CR 206 – Side stand upgrade

XDiavel Model Year 2016-2018 (all versions)

Safety Recall Campaign SRV-RCL-21-001

Spare Parts

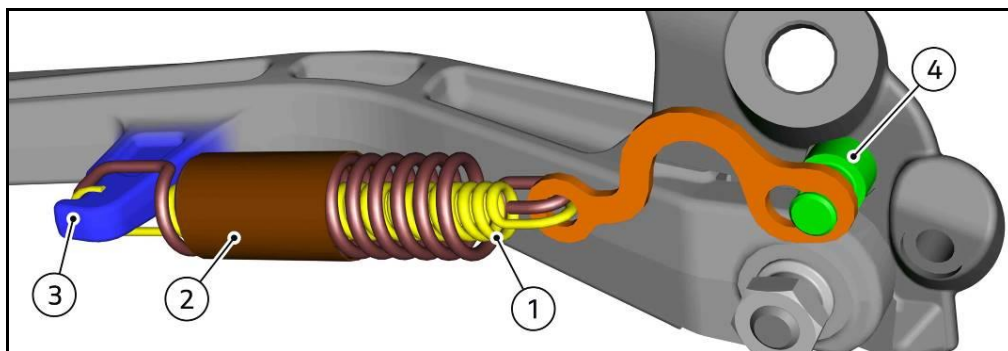
- The side stand bracket with a new totally re-designed version Part no. 55621052AA
- The spring hooking plate with a new version Part no. 82718981AA
- The side stand with a new version Part no. 55610941BA

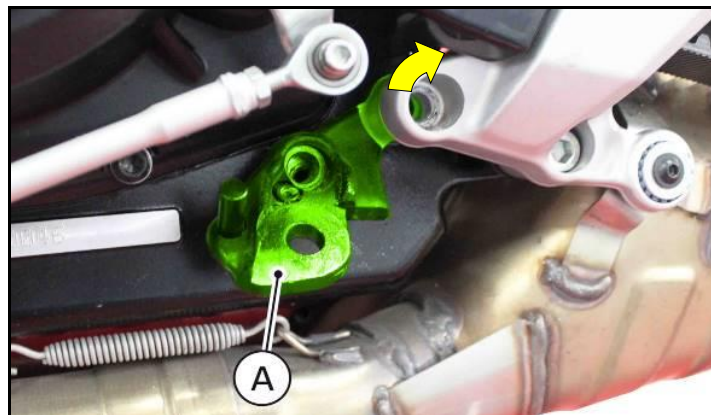
8. Take the new side stand support bracket Part no. 55621052AA.

The new bracket Part no. 55621052AA can be easily identified by the color and by the ribs highlighted in the figure as well as by the "Ducati shield" at the back.

9. Before installing the new side stand support bracket Part no. 55621052AA, thoroughly clean the concerned area to remove any impurities.
10. Remove the Loctite present on screws M10x30 (10) and M10x50 (11).
11. Fit the new **bracket (A)** Part no. 55621052AA between crankcase and LH side bracket, as shown in the figure.
